Airstream Service Bulletin

Bulletin Number: 192

Product Line: 2021 & 2022 Basecamp 20

Subject: 2021 & 2022 Basecamp Battery Box Lid Gasket

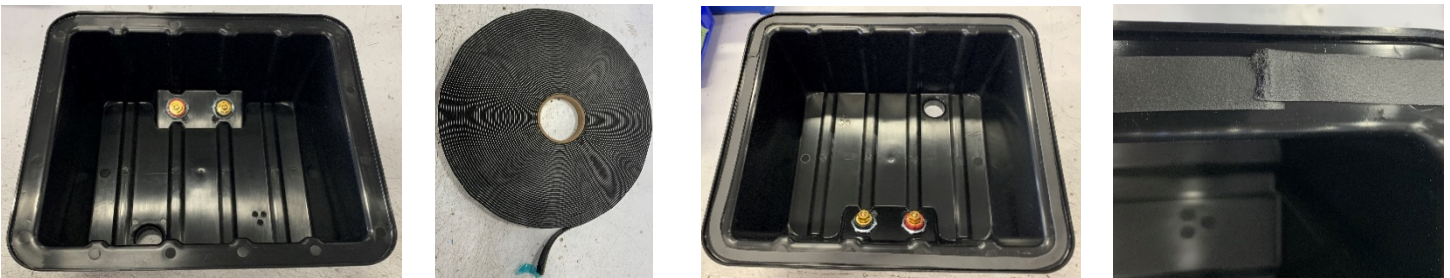
It has come to our attention that in certain model year 2021 & 2022 Basecamp 20 travel trailers, the battery box lid gasket was not installed. In certain situations the batteries may have the potential of outgassing, and without the gasket, the gases may enter the living area of the trailer.

On the Basecamp 20, the battery box is located under the dinette seat, next to the refrigerator cabinet.

The lid has 8 screws holding it to the base. Use a Phillips screwdriver to remove the screws and take the lid off.

The foam tape is self-adhesive, and needs to be applied to the center of the lip, all the way around the lid. Overlap the tape where you started so there are no gaps.

Reinstall the lid, using the 8 screws, and replace the wood cover and cushions.
